Subject: Public Comment to Mayor, Council and Planning Commissioners

Subject: Public Comment to Mayor, Council and Planning Commission Regarding BCHD DEIR

Attached are the comments of BCHD Overdevelopment, a group of Redondo and Torrance residents concerned with the 103-foot tall, 800,000 sqft proposed BCHD commercial, market-priced RCFE proposed to be built on our publicly owned land. Because BCHD is both the proponent and the lead agency, and because BCHD's most recent project plan refers not to an "EIR Decision" date but to an EIR Certification date on September 22, 2021, it is clear that BCHD is failing in its role as lead agency and instead favoring their position as project proponent.

The following public comments below are provided in response to the BCHD DEIR and as public record comments to the agencies and organizations above.

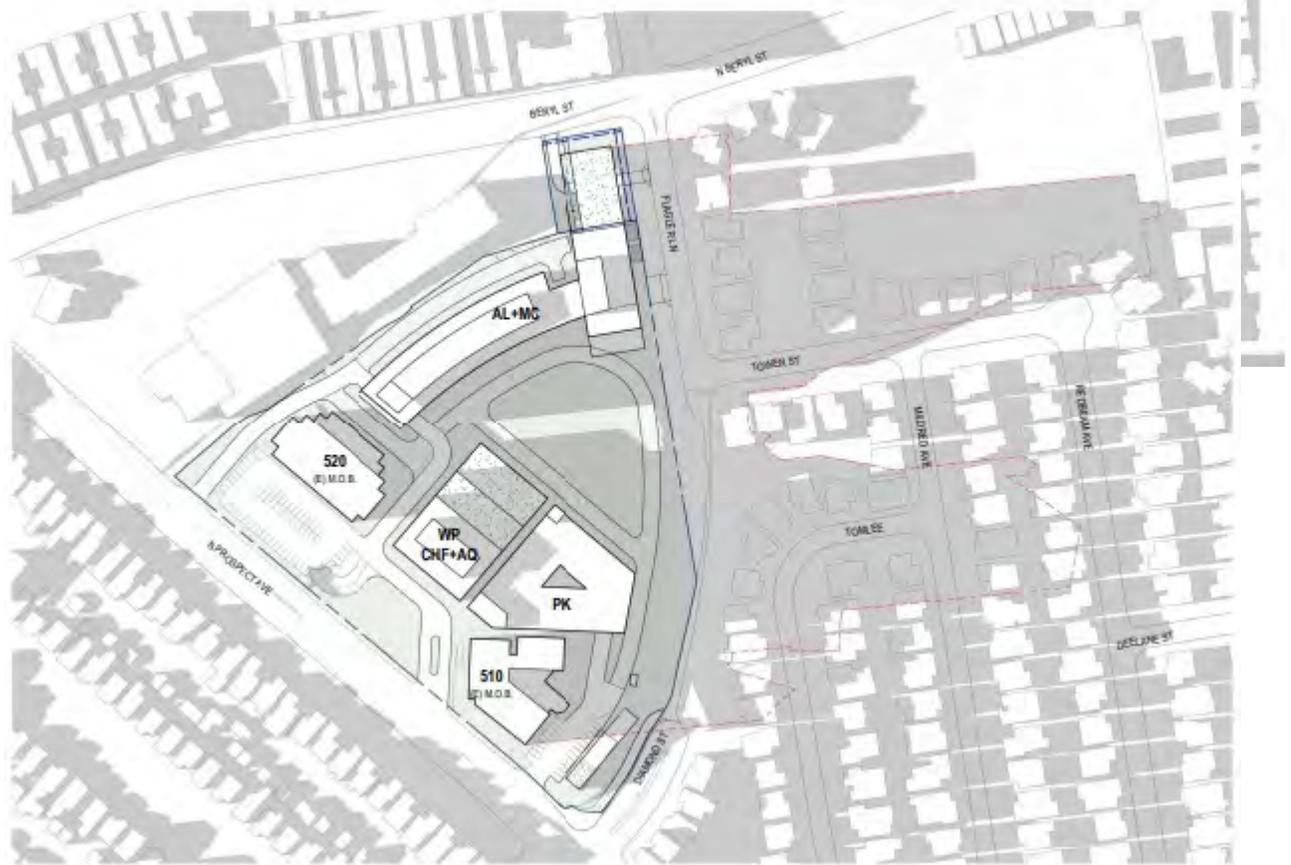
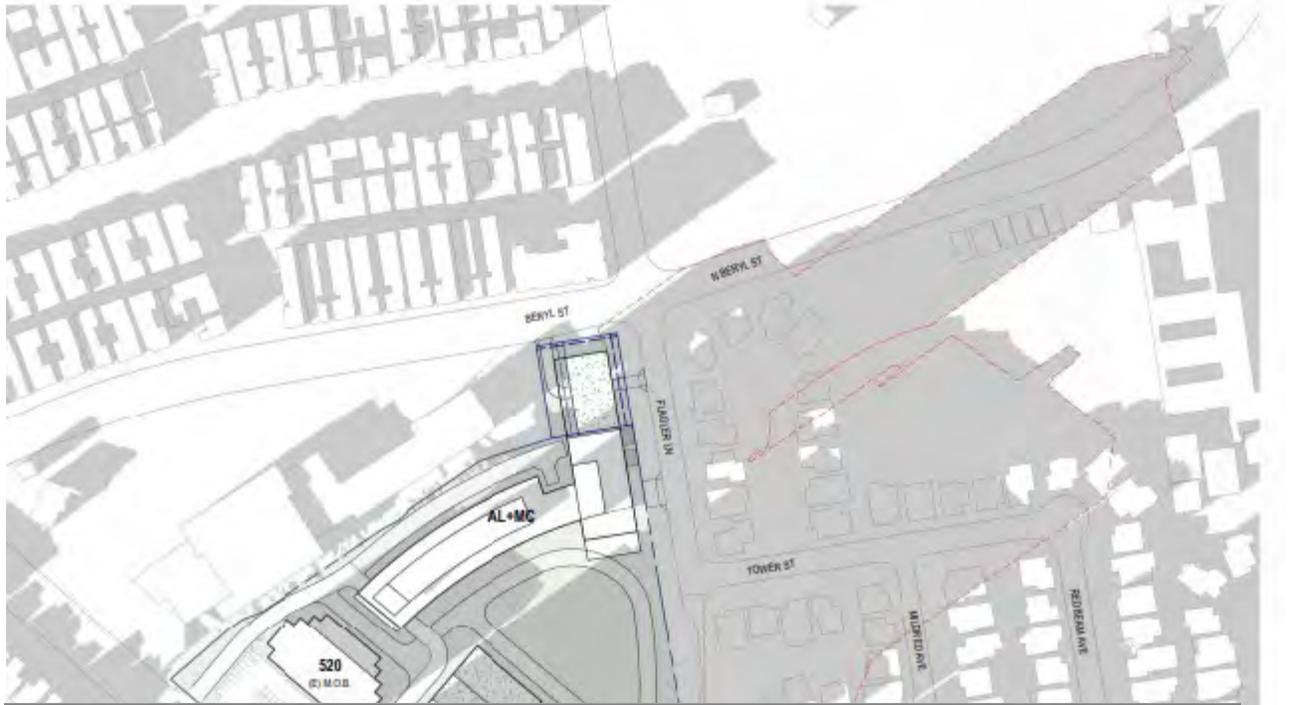
Significant Shading/Shadowing Impacts and BCHD Deficiencies and Errors Include: Illegal Taking of Recreation from the Towers Elementary Fields; Illegal Taking of Sunlight from Adjacent Land Uses of Residential and Public School Required for Health; and Failure to Provide Hourly Shadowing for Public Evaluation.

Because BCHDs shading/shadowing analysis is insufficient, fails to provide hourly data, fails to evaluate negative significant impacts on recreation at Towers and fails to evaluate the negative health impacts of shading/shadowing, it must be correct, reissued, and recirculated for comment.

Due to BCHDs defective and insufficient analysis of shading/shadowing the public is denied intelligent participation in the CEQA process. The images below represent what little can be salvaged to estimate impacts. Based on this evidence, the shading/shadowing impacts represent a significant “taking” of sunlight and recreation from Towers Elementary and surrounding residential uses.
